**Appendix I**  
**Response to Comments**

## Appendix I Response to Comments

The Notice of Availability (NOA) for the November 2007, Watdog Draft Supplemental EIS was published in the Federal Register by the Environmental Protection Agency on December 21, 2007, to commence the 45-day Comment Period. The Comment Period ended on February 10, 2008. Three comment letters were received. Each comment was reviewed and coded based first on content or subject, in this case representing a unique resource program organized by Subject Code, then by intent compiled and recorded using Category Code and Comment IDs.

**Watdog: Stand Structure and Fuel Ladder Potential for CWHR Size Class 4 Stands**

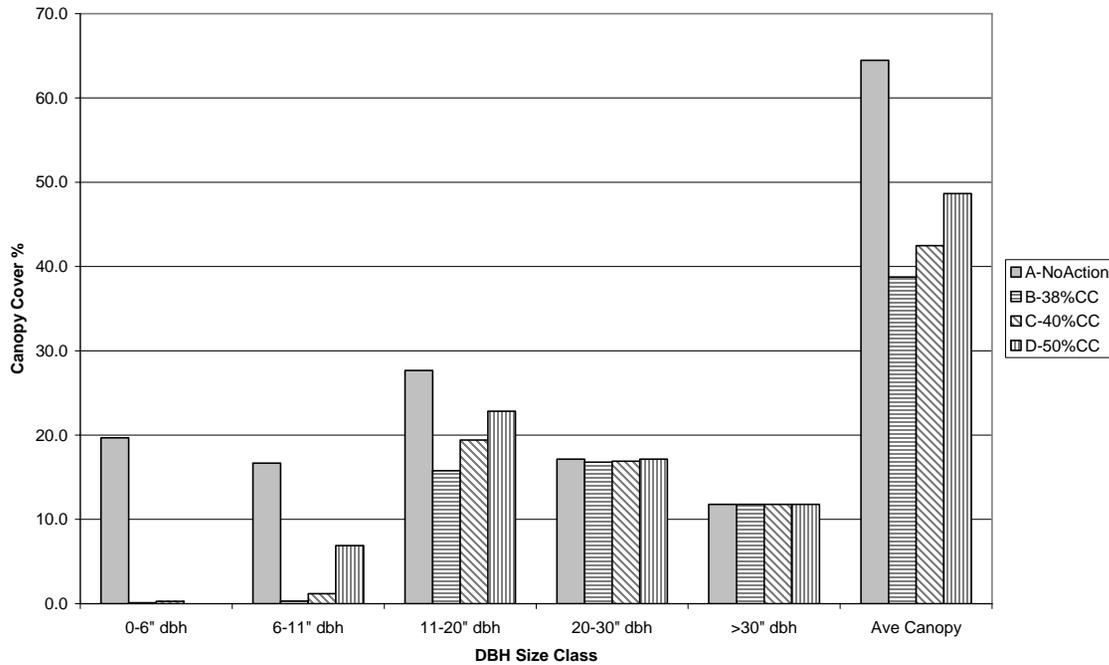
acre. Clearly, the total mortality (harvest plus wildfire) is higher under Alternative B. The FSEIS fails to acknowledge this in the analysis.	
FUEL	700	1-53	<p>Group selections are not compatible with fuel breaks because of the long time in which they are vulnerable to damage from fire and because they produce dramatic fire behavior, and exhibit unsafe conditions for fighting fire during that time. Fuel breaks are intended to be continuous, not broken with group selection areas that result in plantations that are notorious for burning rapidly and with great intensity.</p> <p>Of the three alternatives, Alternative B has the greatest proportion of group selections and would be the alternative most dangerous for the firefighters and more vulnerable to the effects of wildfire..</p>	<p>According to the HFQLG, Appendix J (Fire and Fuels), “Small group selections could be consistent with achieving the desired condition of the DFPZ, if they are placed on the fringe, away from primary control point of the DPFZ, and at density that was consistent with achieving the criteria of maintaining 90 percent of the area in a condition that is not susceptible to torching Weatherspoon (1996) reported that DFPZs will require periodic regeneration of portions of the zone, and long-rotation, low-density versions of group selection might be the best silvicultural method for this purpose” (HFQLG, Appendix J, page 5).</p> <p>For the Watdog Project, Alternative B proposes to place 202 acres of group selection harvests within 4,021 acres of DPFZ, which results in a rate of approximately 5 percent. This density of groups is within the desired conditions for DFPZs (HFQLG, Appendix J).</p> <p>In addition, uneven-aged management, and group selection in particular, results in vertical and horizontal structure more closely associated with pre-settlement forest conditions by breaking up canopy continuity and reducing ladder fuels. This would help change the structure of the forests from even-aged or uneven-aged with a high risk fire ladder potential to the desired condition of uneven-aged, multistory, and fire-resilient.</p> <p>Long-term fire resilience of forested landscapes can be maintained by small group selections conducive to regeneration of fire resistant and shade intolerant ponderosa pine. Group selections permit the maintenance of single canopy layers in any given location, thereby discouraging crown fires (Weatherspoon 1996; Weatherspoon and Skinner 1996) (DEIS, page 3-169).</p>

FUEL	700	1-54	<p>Creating A Fire Resilient Stand Does Not Require Reduction of Canopy Cover to Less Than 50%. Stephens and Moghaddas (2005b) examined a number of stands on which commonly used silvicultural systems had been applied and compared to the</p>	<p>In both of Stephens and Moghaddas papers, stand structure (i.e., saplings, poles, small trees, medium/large trees) by diameter classes is not described. So it is very difficult to determine how removal of canopy cover by stand structure classes would affect residual stand canopy. In one of the papers, they do infer that stands were crown thinned (i.e., removing dominant and co-dominant trees) so that residual trees were well spaced with little overlap of live crowns in dominant and co-dominant trees; followed by thinning from below to maximize crown spacing with approximately 90% of understory conifers and hardwoods between 1 and 10 inches in diameter at breast height (DBH) being masticated in place; and some stands receiving a</p>

Subject Code	Category Code	Comment ID	Comment	Forest Service Response
			<p>predicted fire behavior of these stands to young and old growth reserves.</p> <p>They concluded that “overall, thinning from below and old-growth and young-growth reserves were more effective at reducing predicted tree mortality.”</p> <p>In these stands with the most fire resilient fuel profiles, average canopy cover ranged between 57% and 75%. (Ibid., p. 374).</p> <p>Thus, canopy cover in excess of 50% was consistent with reduced tree mortality in reserved and treated stands.</p>	<p>prescribed burn treatment.</p> <p>Post-treatment residual canopy cover for these treatments ranged from 51 to 58 percent.</p> <p>However, the vegetation type and stand structure from the Watdog Project area is different than the vegetation type and stand structure located at Blodgett Forest Research Station.</p> <p>Specific to the vegetation in the Watdog Project area, it would be incorrect to assume that thinning all stands to a 50 percent or higher canopy would eliminate all of the ladder fuels. Stand canopy cover is highly dependent u species (true firs have narrow crowns when compared to ponderosa or Jeffrey pines), tree size, and tree spacing or density (open grown trees have wider crowns than closely spaced trees).</p> <p>Therefore, it is very important to provide a stand structure table by diameter classes to display the fuel ladder potential of a specific stand.</p> <p>The Watdog Project Silviculture Report, Appendix A, tables A-15, A-16, A-17, A-18, and A-19 displays the stand structure and fuel ladder potential by dbh size classes for each stand.</p> <p>In addition, Appendix G of the Watdog Project Silviculture Report, contain a series of photographs and associated tables in attachments A, B, C and D that illustrate that the saplings and pole size trees make up the fuel ladder. Figure 1 below graphically displays the average stand structure and fuel ladder potential for the CWHR 4 stands.</p>

Consequently, in the Watdog Project area, defensible fuel profile zones (DFPZs) would not be effective at 50 percent or higher canopy cover because small trees that could draw ground fires up into the crowns of large trees would have to be left.

Maintaining a 50 percent or higher canopy cover would result in the retention of sapling (i.e., 0-6" dbh) and pole size ladder fuels (i.e., 6-11" dbh).

Most of the canopy cover reduction would occur in the sapling (i.e., 0-6" dbh), pole (i.e., 6-11" dbh), and small tree size classes (i.e., 11-20 inches dbh).
